## ITASCA DOCUMENT REVIEW

Document: "The State of In-Situ Stresses Determined by Hydraulic Fracturing at the Hanford Site" by Kunsoo Kim, Steven A. Dischler, James K. Aggson, and Michael P. Hardy (RHO-BW-ST-73P)

Reviewer: Itasca Consulting Group, Inc.  
(M. Board)

Date Review Completed: 25 July 1986

Fig. 1 Seismicity in the Pasco Basin as Determined from the Site Monitoring System

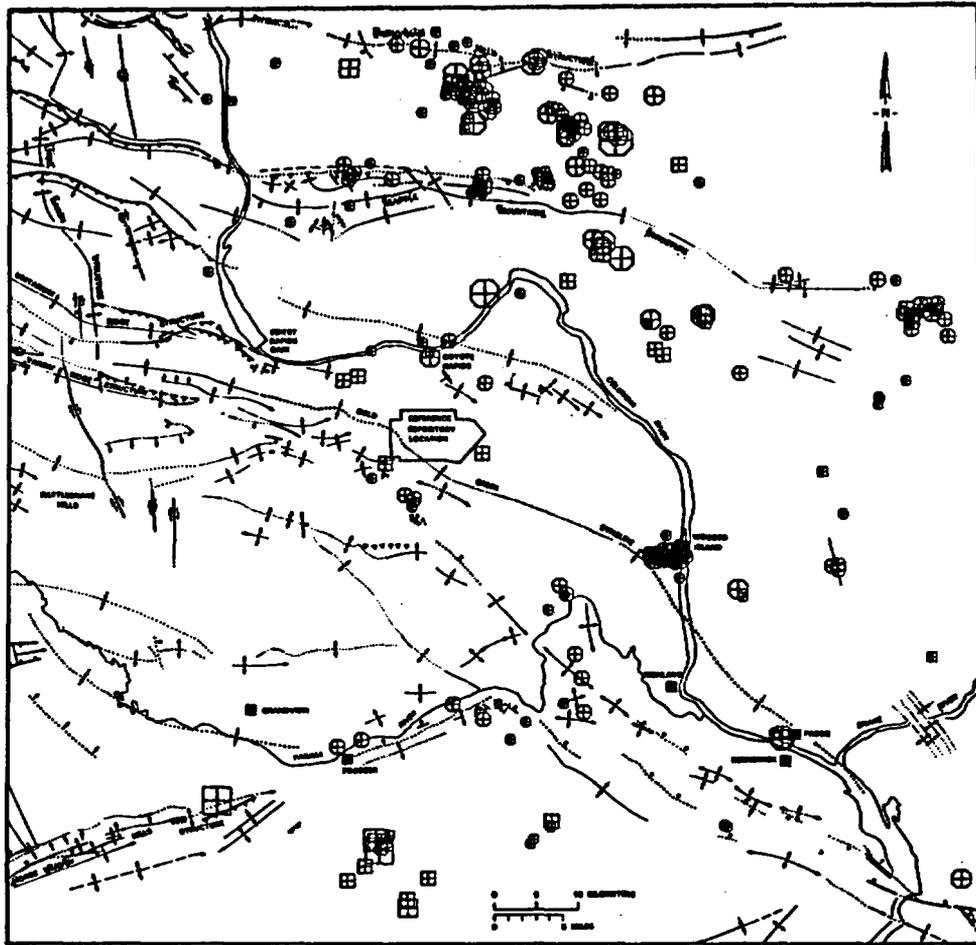
As a rock mass undergoes yield, seismic energy is released. The rate and magnitude of these releases are indicators of the intensity of the applied stress field. Seismicity at the Hanford site is characterized by shallow microearthquake "swarms" consisting of up to 100 earthquakes of magnitude 1 to 3.5. These swarms typically last a few days to several months and occur within a rock volume roughly 5km on a side. About 75% of all microearthquakes occur at depths of less than 4,000m. Figure 1 shows the location of swarm activity, which is greatest in the Saddle Mountains and Frenchman Hills structures as well as Wooded Island at the eastern boundary of the site. Focal mechanisms indicate a major north-south horizontal compression with a vertical minimum compression. This is consistent with east-west trending fold axes and sub-parallel thrust or reverse faulting.

Fig. 2 Illustration of Hydraulic Fracturing Terminology  
(In the present case,  $P_o \approx P_h$ .)

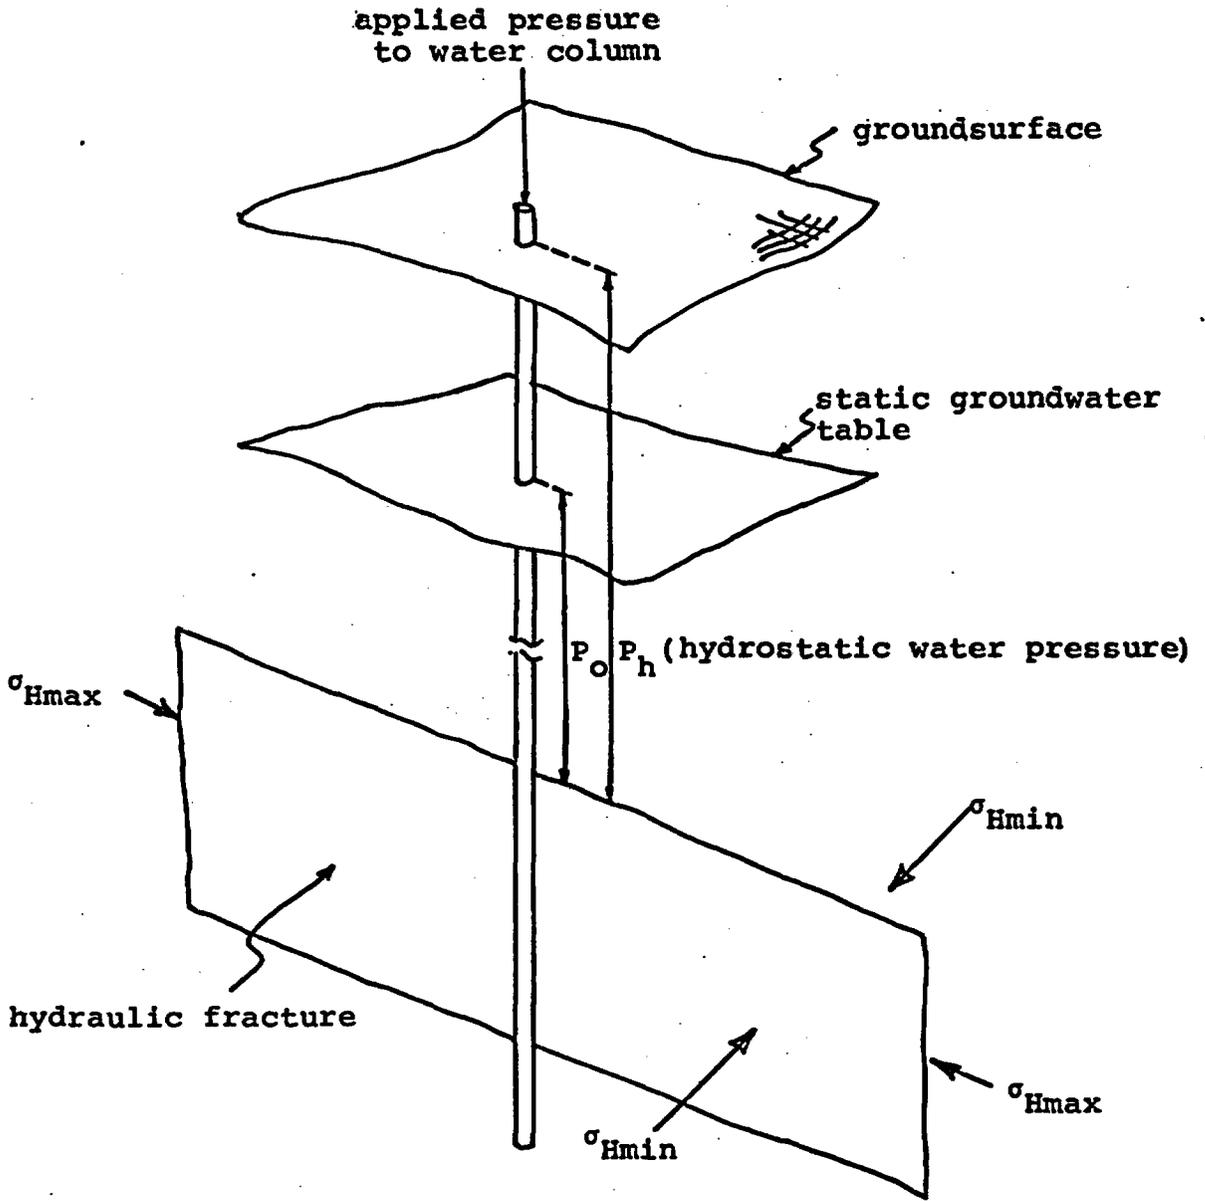
Figure 2 is a schematic which illustrates these quantities. In a crystalline rock with low permeability, it is questionable whether communication between fracture and the water pressure is established. The conservative assumption is that the pore pressure term be neglected from the above equation. The authors argue that the pore pressure be included in the analysis, citing work by Hickman and Zoback (1982) as supporting their position. Although we agree in principle with this approach, it is felt that, for re-

pository design, the most conservative method (i.e., zero pore pressure) should be chosen.

Fig. 3: (a) Horizontal Stresses as a Function of Depth  
(b) Stress Ratios as a Function of Depth

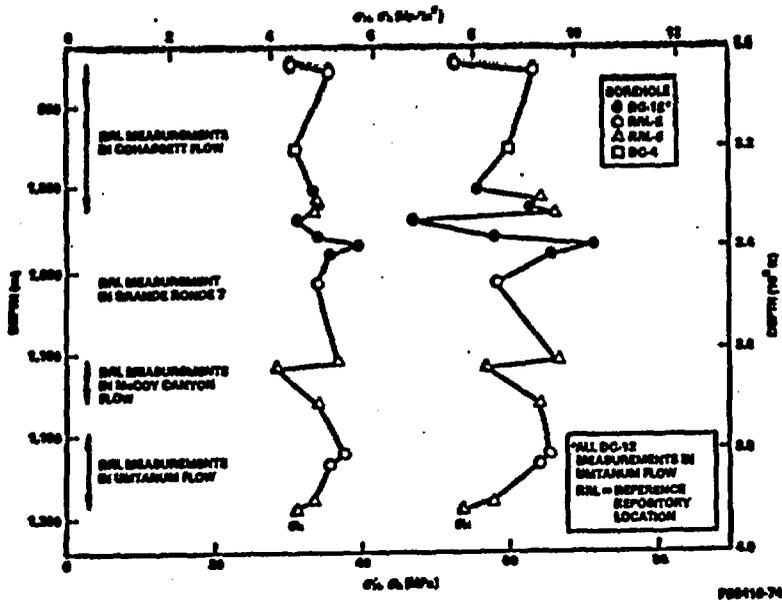
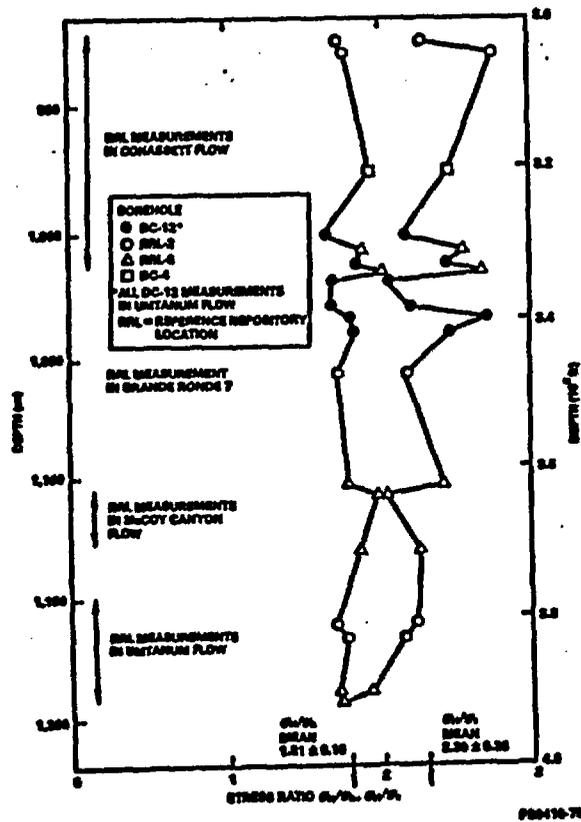
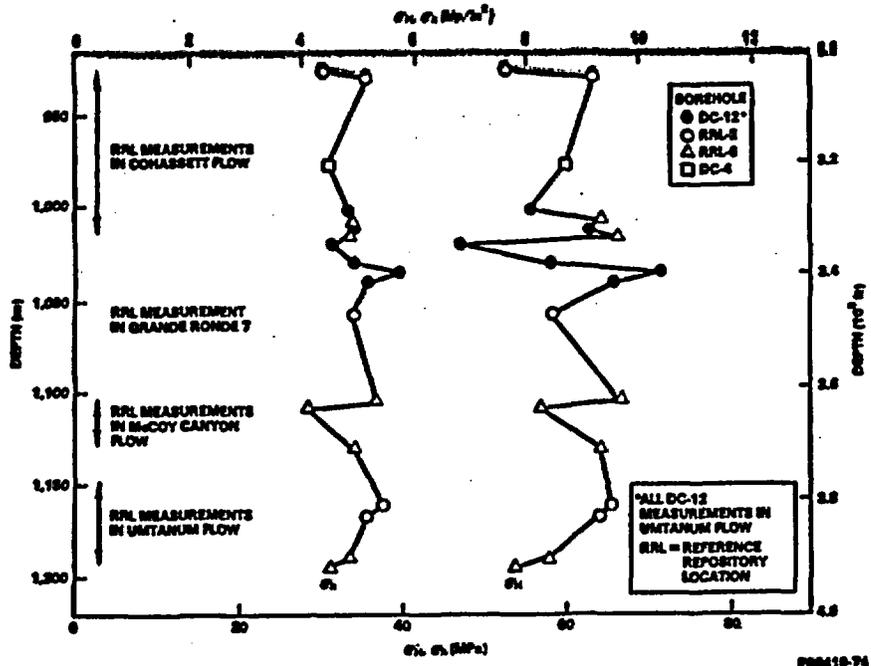
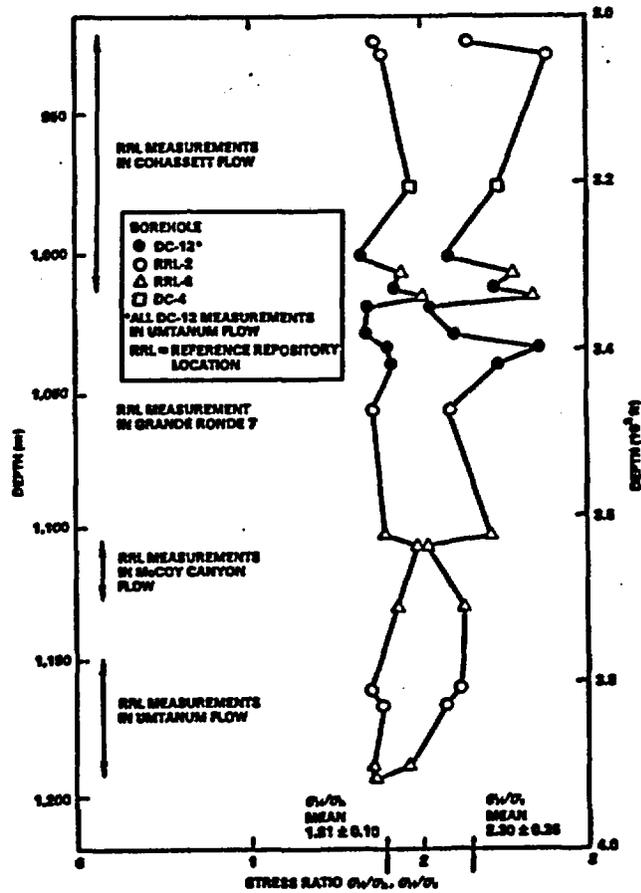
1. There is no consistent change in horizontal stress with depth nor is there a consistent change in stress ratio with depth (Fig. 3). It appears that any variation with depth is masked by scatter in the data.
2. Measurements of horizontal stress from the Umtanum Flow within and outside the RRL indicate little lateral variation in stress; however, there is too little data to make this assertion confidently. It is reasonable to assume that the stresses are consistent laterally within the RRL.
3. The data consistently indicates a north-south major horizontal compression. This correlates well with geologic data discussed earlier.

Fig. 4 Mohr Envelope Plot of Stress States Given in Table 4

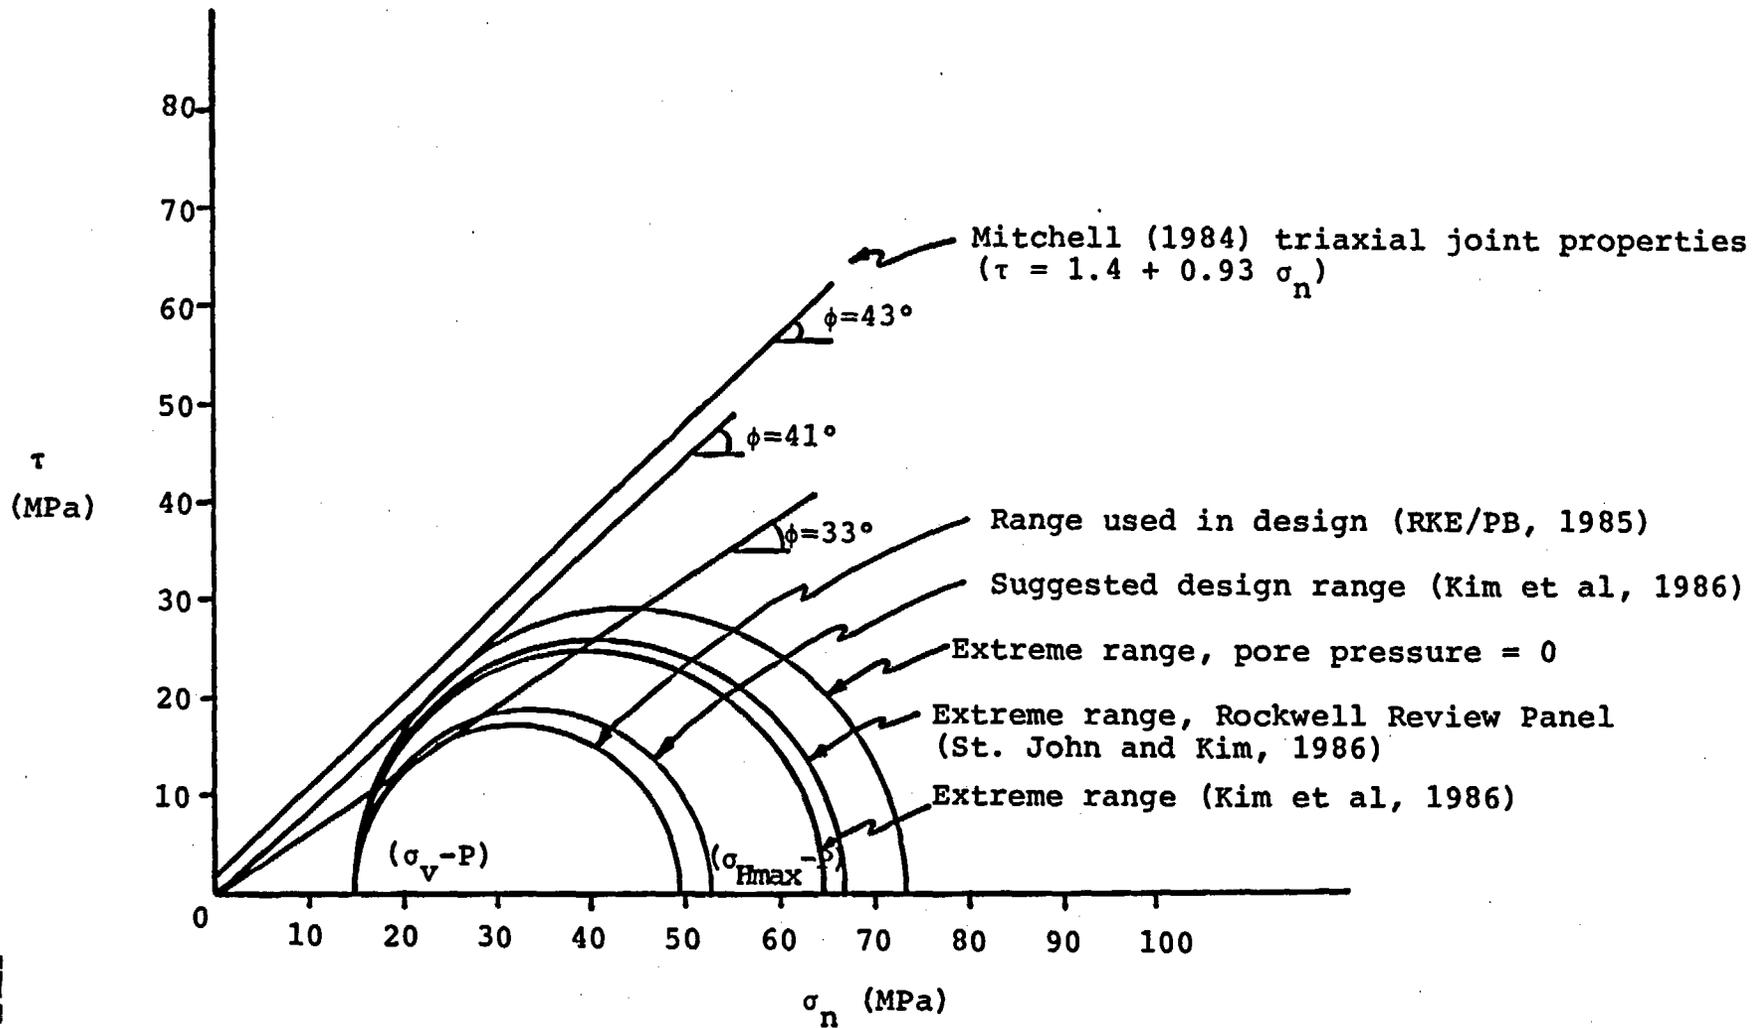
The analysis of possible fault or joint slippage under the influence of the in-situ stresses presented on pp. 57-59 must also be examined in the light of the extreme data ranges. This analysis indicates that in-situ joint friction would have to be as low as 33° (with no cohesive strength) for slip to occur. It is suggested that microseismic events at the site are related to small areas of joints where the friction angle is low or at joint intersections. A plot of the Mohr envelopes for the extreme data ranges is given in Fig. 4. Here, the range of extreme values for the  $\sigma_{Hmax}, \sigma_y$  envelope are plotted for all stress values discussed in this review. As seen, the ranges of stress recommended by Kim et al (1986), the review panel, and this review are fairly similar and suggest slip on surfaces with a friction angle of about 40° for cohesive joints.

(This plot shows that for the extreme stress states, slip could occur on favorably-oriented joints with friction angles of  $40^\circ \pm$ .)
